# UNITED STATES PATENT AND TRADEMARK OFFICE

APPLICATION NO.	FILING DATE	FIRST NAMED INVENTOR	ATTORNEY DOCKET NO.	CONFIRMATION NO.
10/588,006	09/20/2006	Quentin Baillia-Prel	0579-1128	1367

<b>Office Action Summary</b>	<b>Application No.</b> 10/588,006	<b>Applicant(s)</b> BAILLIA-PREL, QUENTIN	
	<b>Examiner</b> CARLOS LUGO	<b>Art Unit</b> 3673

attachment #1

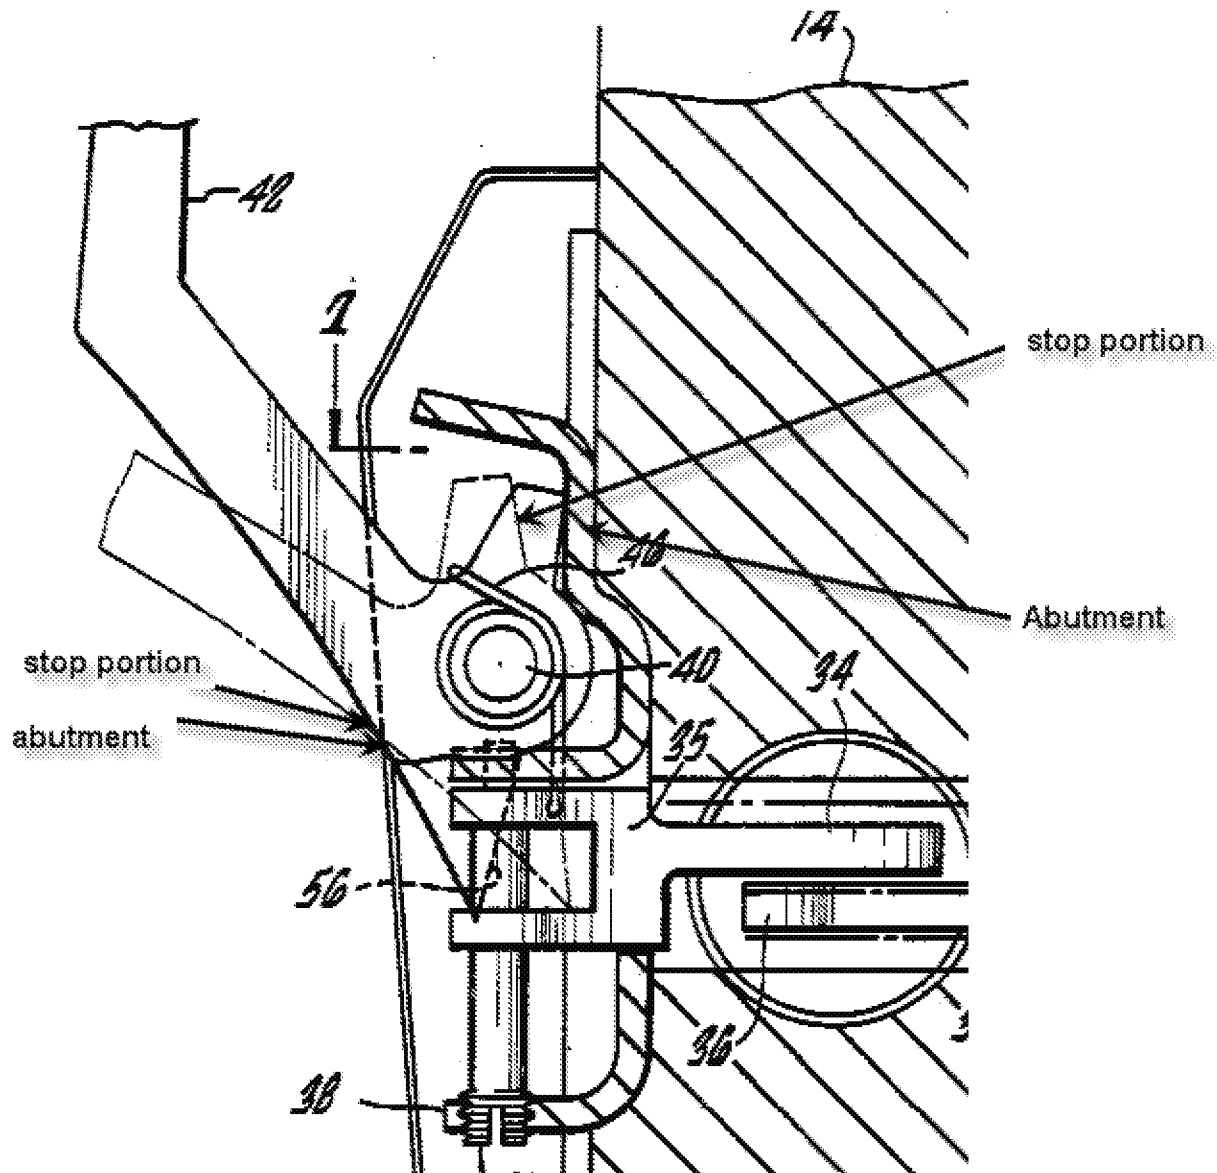
The fixed part has an abutment configured to cooperate with a stop on the bar (attachment #1) to delimit a range of pivot motion.

The profiled section comprises a maneuvering portion (painted surface, attachment #2) between the pivot and the stop portion.
